Access Compliance Report

Public Rights-of-Way

Intersection ID: 24343	Main Street: BIRNEN_DR	Cross Street: LANDSBURG_LN	Location: NE
ADA ID: 2721692E85A8	Ramp Type: PerpDiag	Initial Pass/Fail: Fail	Overall Compliance: No
		Severity Score: 10

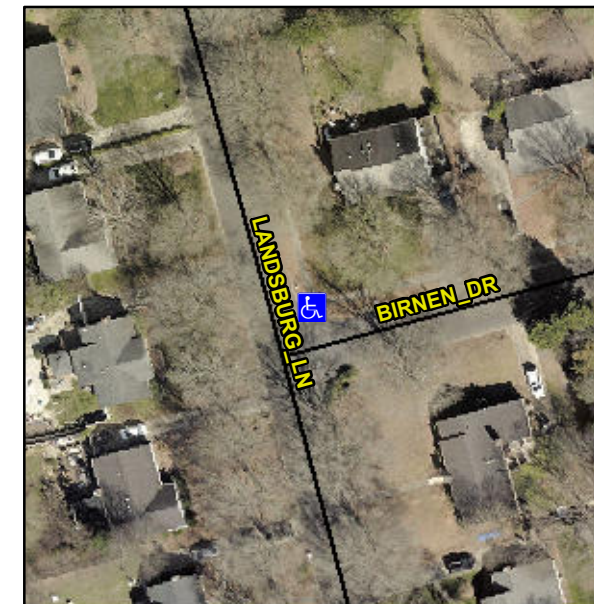
Not Found, R304.5.1, R304.5.3

Compliance	Description	Data	Compliance	Description	Data
N/A	Ramp Length (in)	68.0	Yes	Ramp Slope (%)	6.1
No	Ramp Width (in)	40.0	No	Ramp XSlope (%)	4.4
N/A	Flare Type LT	N/A	N/A	Flare Type RT	N/A
N/A	Flare Slope LT (%)	N/A	N/A	Flare Slope RT (%)	N/A
N/A	Flare Traversable LT?	N/A	N/A	Flare Traversable RT?	N/A
N/A	Landing Length (in)	N/A	N/A	DWS Provided?	N/A
N/A	Landing Width (in)	N/A	N/A	DWS Contrast?	N/A
N/A	Landing Slope (%)	N/A	N/A	DWS Length (in)	N/A
N/A	Landing X Slope (%)	N/A	N/A	DWS Full Width?	N/A
N/A	Landing Curb? (Y/N)	N/A	N/A	DWS Offset (in)	N/A
N/A	Shared Landing?	N/A			
N/A	Gutter Ponding?	N/A	N/A	Gutter Slope (%)	N/A
N/A	Gutter Lip Ht (in)	N/A	N/A	Gutter X Slope (%)	N/A
N/A	Painted X Walk1?	No	N/A	Painted X Walk2?	No
	X Walk 1 Direction	To W		X Walk 2 Direction	To S
N/A	X Walk 1 Width (in)	N/A	N/A	X Walk 2 Width (in)	N/A
	X Walk 1 Slope (%)	1.4		X Walk 2 Slope (%)	1.2
	X Walk 1 X Slope (%)	2.0		X Walk 2 X Slope (%)	2.0

Remove & Replace Curb Ramp With Two New Directional Ramps or Equivalent.
